ADDENDUM

PROJECT NAME: Village By The Station 18 Bed Addition

PROJECT NO.: 22181.000 DATE: 2022-12-01

ADDENDUM NO.: E-1 ISSUED BY: Bruce Candline

3. IRRIGATION EQUIPMENT (LANDSCAPE DRAWING L1-101)

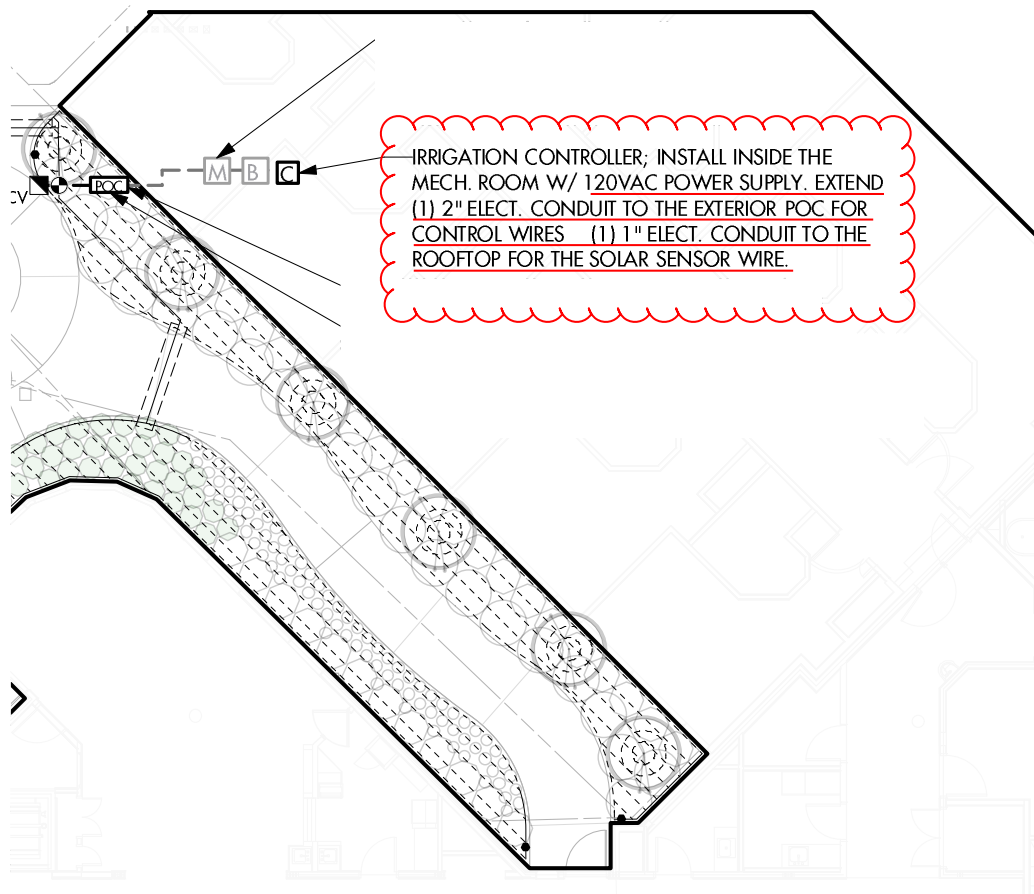
1. Note electrical requirements below:
